APPLICATION NO.	FILING DATE	FIRST NAMED INVENTOR	ATTORNEY DOCKET NO.	CONFIRMATION NO.
10/809,210	03/25/2004	Paul E. Freude	ITFT-PEV104US	6561
23122	7590	11/30/2005	EXAMINER	
RATNERPRESTIA P O BOX 980 VALLEY FORGE, PA 19482-0980			COOLEY, CHARLES E	
			ART UNIT	PAPER NUMBER
			1723	
DATE MAILED: 11/30/2005

Office Action Summary

NON-FINAL OFFICE ACTION

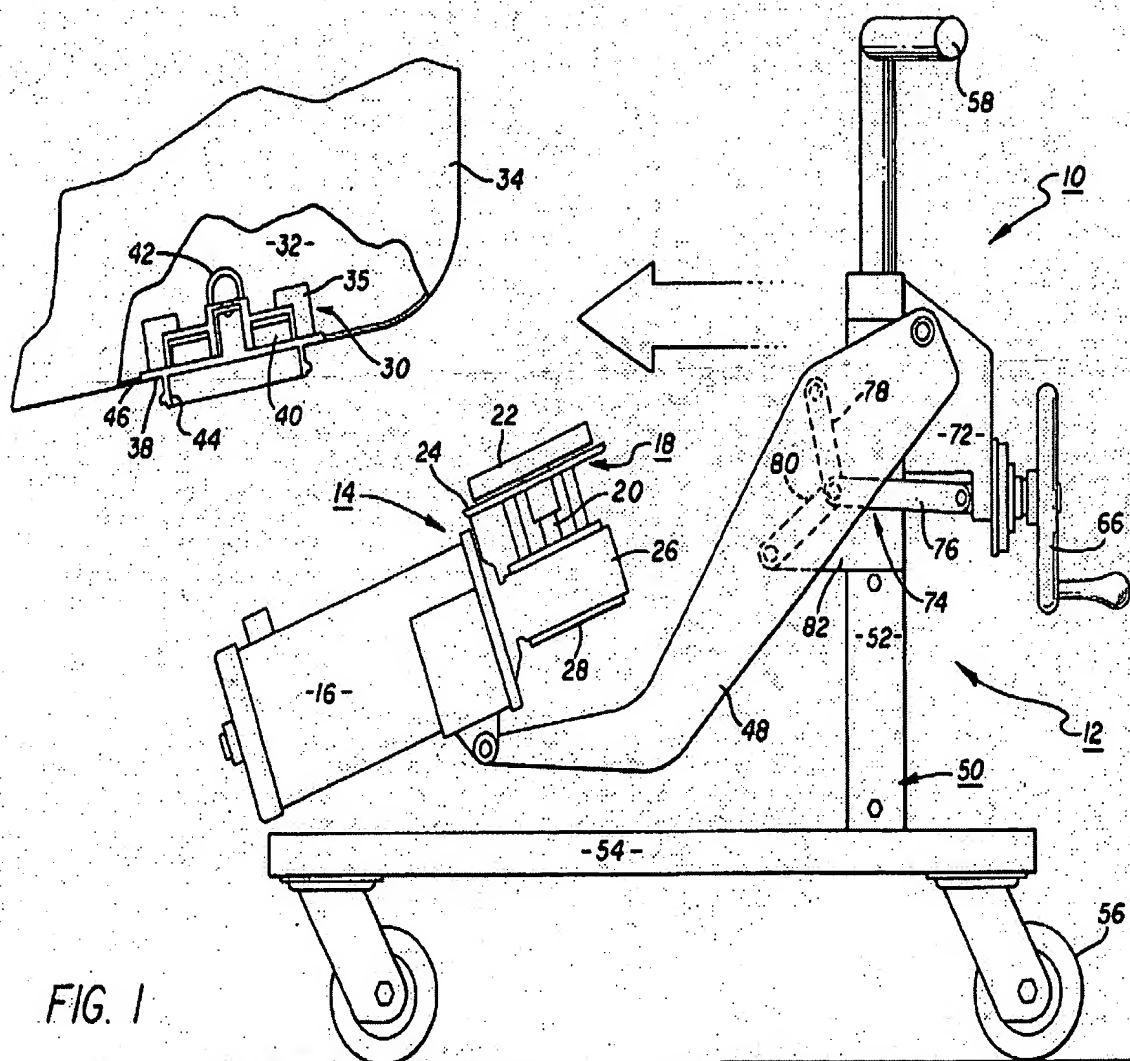
The patent to Rains (US 5,378,062) discloses a method and a system as seen in the Figures below comprising a tank 34; a bottom mount mixer 30 in the tank; a mixer magnetic coupling 40 with a shaft (below 42); docking station 12 with a mixer drive 16, 28, 18 with a magnetic coupling 22; the docking station having a cantilevered linkage 74; tank receiving member 38; tank engagement facilitating component 44 or latch portions 24, 44 which mate with each other as seen in Fig. 2; support frame 50; the docking station having a bottom plate 54 with wheels 56; components 48, 76, 78, 80 for maintaining engagement between the tank and the docking station.

FIG. 1 shows a transporter system 10 of the present invention. The transporter system 10 includes a transporter 12 which supports a motor/magnetic mixer assembly 14. The motor mixer assembly 14 includes a motor 16 and an outer magnetic mixer assembly 18. The motor 16 has an output shaft 20 which is connected to a drive magnet 22 that extends from an outer mixer frame 24. The outer mixer frame 24 is captured by a collar 26 which extends from the motor 16. The output shaft 20 shown is typically coupled to another output shaft (not shown) that extends from the motor and is perpendicular to the shaft 20. The shaft 20 and the output shaft of the motor 16 are coupled by a gear box 28 which translates rotation of the motor shaft into rotation of the output shaft 20. Rotation of the Output shaft 20 rotates the drive magnet 22 accordingly. The outer magnetic mixer assembly 18 is adapted to be coupled to an inner magnetic mixer assembly 30 located within an inner cavity 32 of an agitator tank 34. The inner mixer assembly 30 has an impeller 36 that can rotate relative to an inner mixer frame 38. The inner mixer assembly 30 also contains a driven magnet 40 which rotates the impeller 36. Extending from the top of the impeller 36 is a handle 42 which allows the operator to place the inner assembly 30 into the tank 34. The inner mixer frame 38 has an annular sleeve receptacle 44 that extends through an opening 40 in the tank 34. The

sleeve 44 is adapted to receive the drive magnet 22 of the outer magnetic mixer assembly 18 and align the drive magnet 22 with the driven magnet 40. The motor/magnetic mixer assembly 14 is supported by an arm 48 that is pivotally connected to a frame 50. The frame 50 has a support beam 52 that is mounted to a baseplate 54. Attached to the baseplate 54 are a plurality of wheels 56. The frame 50 may also have a handle 58 which allows an operator to move the transporter 12 from one location to another location.

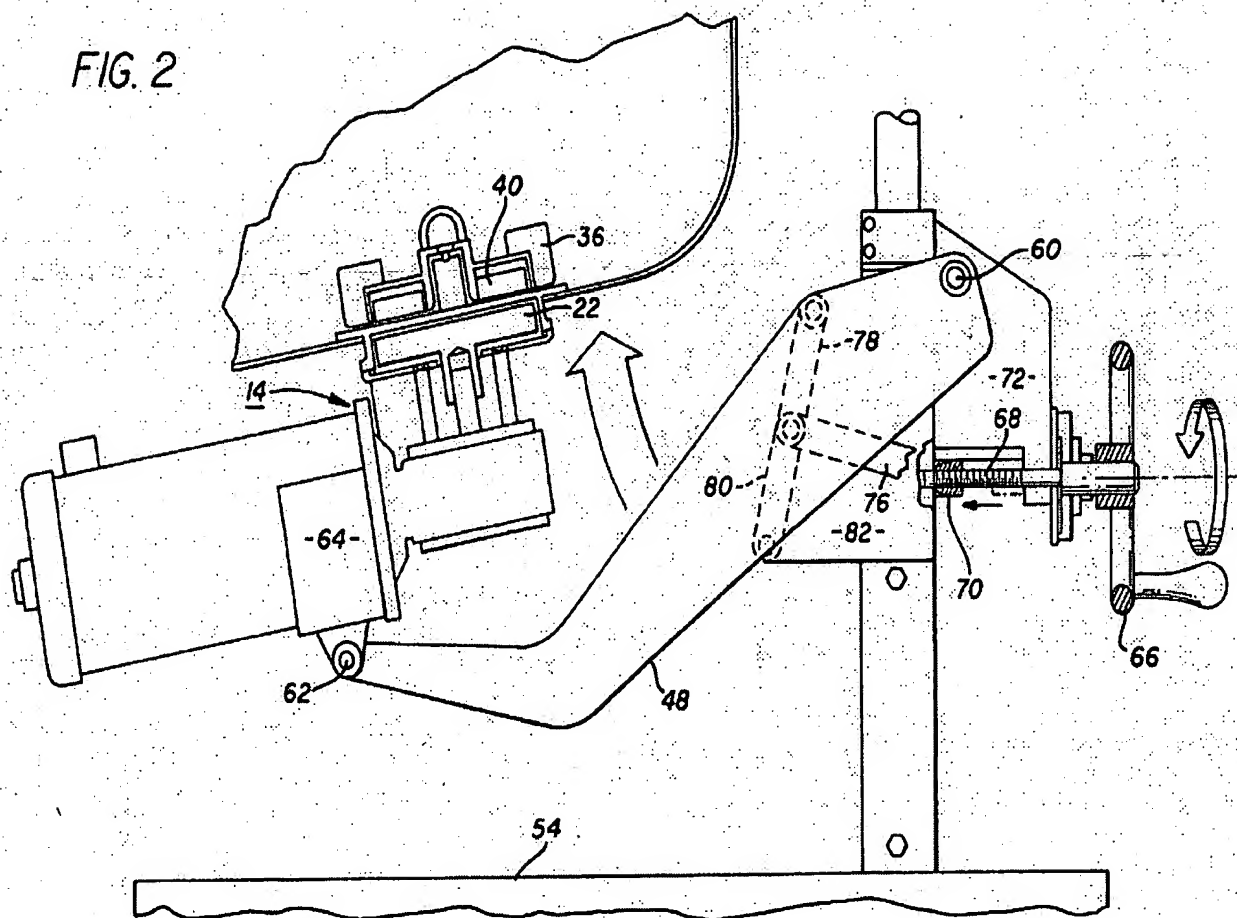
As shown in FIG. 2, the arm 48 is adapted to be rotated and to move the motor/magnetic mixer assembly 14 between a first position and a second position shown in FIG. 2. When the assembly 14 is in the second position, the drive magnet 22 is magnetically coupled to the driven magnet 40. When the assembly is in the second position, rotation of drive magnet 22 will induce rotation of the driven magnet 40 and the accompanying impeller 36. The arm 48 may pivot about a first pin 60. The arm 48 may also have a second pin 62 which allows the motor/magnetic mixer assembly 14 to rotate relative to the arm 48. The motor/assembly 14 may be coupled to the second pin 62 by a housing 64 which supports the motor 16. The second pin 62 allows the outer mixer assembly 18 to pivot, so that the drive magnet 22 is coaxial with the driven magnet 40 when rotated into the second position.

The transporter 12 preferably contains a device or mechanism which provides a mechanical advantage in rotating the arm 48, so that an operator can move the motor/magnetic mixer assembly 14 with relatively little effort. As shown in FIGS. 1 and 2, the transporter 12 may have a wheel 66 that can be rotated by the operator. The

wheel 66 has a shaft 68 that extends through a threaded aperture 70 in a frame bracket 72. The wheel shaft 68 is coupled to a linkage mechanism 74 which includes a push rod 76 pivotally connected to the shaft 68, the arm 48 and a pair of secondary rods 78 and 80. The first secondary rod 78 is pivotally connected to the arm 48. The second secondary arm 80 is pivotally connected to bracket 82. Rotation of the wheel 66 moves the push rod 76, which rotates the arm 48 and mixer assembly 14. As shown in FIG. 2, the secondary arms 78 and 80 are moved into an over-center position to lock the arm 48 and mixer assembly 14 into the second position. Although a threaded shaft/wheel arrangement is shown and described, it is to be understood that the present invention may employ other arm rotation means such as an electric, or hydraulic motor.

In operation, the transporter 12 is moved so that the motor/magnetic mixer assembly 14 is in the first position shown in FIG. 1. As shown in FIG. 2, the arm 48 is then rotated so that the drive magnet 22 is coupled to the driven magnet 40. The motor 16 is then activated so that the impeller 36 is rotated within the tank 34. After a predetermined time interval, the motor 16 can be stopped and the arm 48 rotated to move the outer magnetic mixer assembly 18 back into the first position. The transporter 12 can then be moved to another tank, where the process is repeated. The present invention thus allows a single motor/magnetic mixer assembly to operate a plurality of agitator tanks. The transporter system is particularly useful in mixing pharmaceuticals which require periodic mixing. Each tank can be synchronized so that one motor/mixer assembly can sequentially mix a plurality of agitator tanks.
